# Access Compliance Report

## Public Rights-of-Way

### (Curb Ramps)

Intersection ID: 14409	Main Street: LABURNUM_AV	Cross Street: LORNA_ST	Location: S
ADA ID: F035B07F4C60	Ramp Type: Perp	Initial Pass/Fail: Fail	Overall Compliance: No
Severity Score: 12.5			
Codes/Mitigation Info/Possible Solution		Field Measurements/Component Compliance

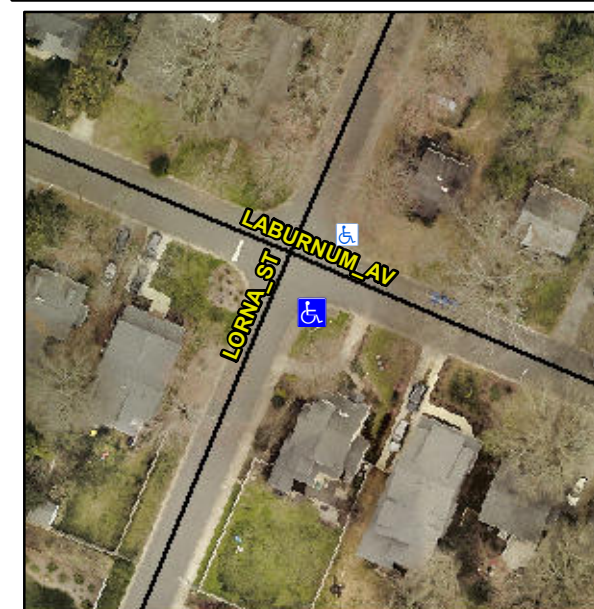
**Not Found, R304.2.2**

Compliance	Description	Data	Compliance	Description	Data
N/A	Ramp Length (in)	61.5	No	Ramp Slope (%)	8.4
Yes	Ramp Width (in)	48.0	Yes	Ramp XSlope (%)	0.2
N/A	Flare Type LT	N/A	N/A	Flare Type RT	N/A
N/A	Flare Slope LT (%)	N/A	N/A	Flare Slope RT (%)	N/A
N/A	Flare Traversable LT?	N/A	N/A	Flare Traversable RT?	N/A
N/A	Landing Length (in)	N/A	N/A	DWS Provided?	N/A
N/A	Landing Width (in)	N/A	N/A	DWS Contrast?	N/A
N/A	Landing Slope (%)	N/A	N/A	DWS Length (in)	N/A
N/A	Landing X Slope (%)	N/A	N/A	DWS Full Width?	N/A
N/A	Landing Curb? (Y/N)	N/A	N/A	DWS Offset (in)	N/A
N/A	Shared Landing?	N/A			
N/A	Gutter Ponding?	N/A	N/A	Gutter Slope (%)	N/A
N/A	Gutter Lip Ht (in)	N/A	N/A	Gutter X Slope (%)	N/A
N/A	Painted X Walk1?	No	N/A	Painted X Walk2?	N/A
	X Walk 1 Direction	To NE		X Walk 2 Direction	N/A
N/A	X Walk 1 Width (in)	N/A	N/A	X Walk 2 Width (in)	N/A
	X Walk 1 Slope (%)	3.8		X Walk 2 Slope (%)	N/A
	X Walk 1 X Slope (%)	2.8		X Walk 2 X Slope (%)	N/A

**Remove & Replace Entire Ramp.**
